Washer Fluid Reservoir Rattles While Driving on Rough Roads

F23 (2 Series Convertible)

Produced from August 13, 2014 to December 7, 2014

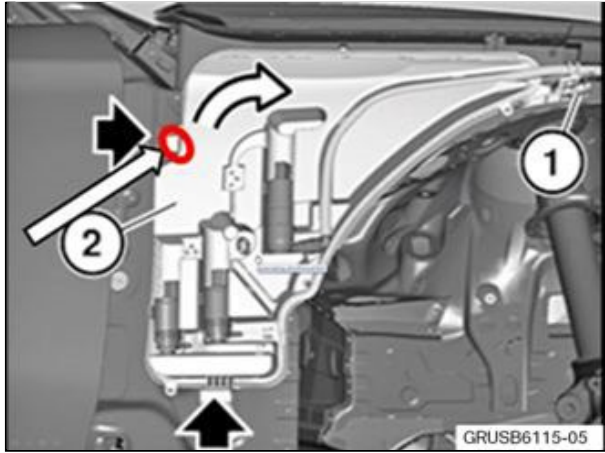
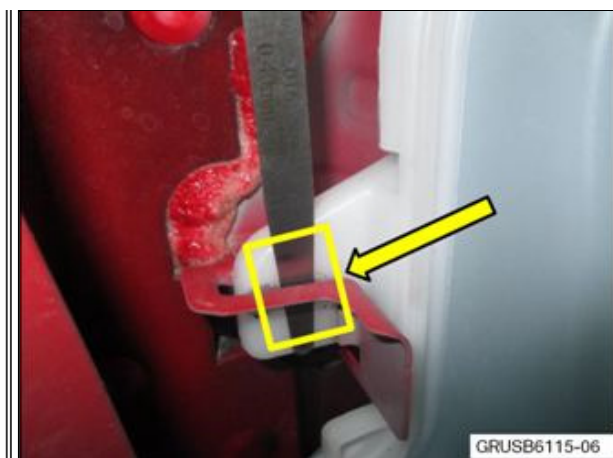
The customer complains of rattling noises from the glove compartment area.

The windshield washer reservoir upper plastic locating guide tab has too much lateral play.

Apply a piece of self-adhesive felt tape to the upper plastic locating guide of the washer fluid reservoir.

<p>Note: The picture shown is with the passenger side fender removed for clarity purposes. Remove the screw (1). The tightening torque is 8 Nm. Pull the washer fluid reservoir (2) out of the guides (arrow) in the direction of the arrow. Unlock and disconnect all plug connections. Unlock the filler hose and pull it off the fitting on the washer fluid reservoir.</p> <p>Note: Catch any escaping washer fluid if necessary.</p>
	<p>The close-up picture shows a gap (0.40 mm) that exists between the plastic reservoir guide and the metal securing bracket. With the reservoir removed, clean the upper guide tab with a clean cloth. Prepare a piece of felt tape (80 x 60 x 1 mm) and apply it to the guide tab in the area shown. The felt tape will eliminate</p>

the rattling noises coming from the metal bracket which can transmit into the glove compartment area. Reinstall the removed parts in the reverse order of their removal.
